# Access Compliance Report

## Public Rights-of-Way

Intersection ID: 26367	Main Street: BEVINGTON_PL	Cross Street: GLYNMOOR_LAKES_DR	Location: SW
ADA ID: 2DFCA02D4B7D	Ramp Type: BlendTrans2	Initial Pass/Fail: Fail	Overall Compliance: No
		Severity Score: 8.75

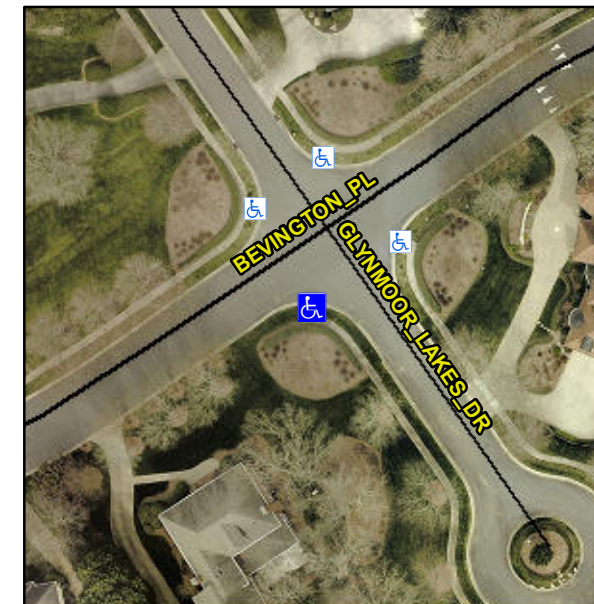
**R304.5.1**

Compliance	Description	Data	Compliance	Description	Data
N/A	Ramp Length (in)	122.0	Yes	BlendTrans Slope (%)	4.1
No	Ramp Width (in)	38.0	Yes	BlendTrans XSlope (%)	1.2
N/A	Flare Type LT	N/A	N/A	Flare Type RT	N/A
N/A	Flare Slope LT (%)	N/A	N/A	Flare Slope RT (%)	N/A
N/A	Flare Traversable LT?	N/A	N/A	Flare Traversable RT?	N/A
N/A	Landing Length (in)	N/A	N/A	DWS Provided?	N/A
N/A	Landing Width (in)	N/A	N/A	DWS Contrast?	N/A
N/A	Landing Slope (%)	N/A	N/A	DWS Length (in)	N/A
N/A	Landing X Slope (%)	N/A	N/A	DWS Full Width?	N/A
N/A	Landing Curb? (Y/N)	N/A	N/A	DWS Offset (in)	N/A
N/A	Shared Landing?	N/A			
N/A	Gutter Ponding?	N/A	N/A	Gutter Slope (%)	N/A
N/A	Gutter Lip Ht (in)	N/A	N/A	Gutter X Slope (%)	N/A
N/A	Painted X Walk1?	No	N/A	Painted X Walk2?	No
	X Walk 1 Direction	To NE		X Walk 2 Direction	To NW
	X Walk 1 Width (in)	N/A		X Walk 2 Width (in)	N/A
	X Walk 1 Slope (%)	0.8		X Walk 2 Slope (%)	0.1
	X Walk 1 X Slope (%)	1.1		X Walk 2 X Slope (%)	1.4

**Remove & Replace Curb Ramp With Two New Directional Ramps or Equivalent.**
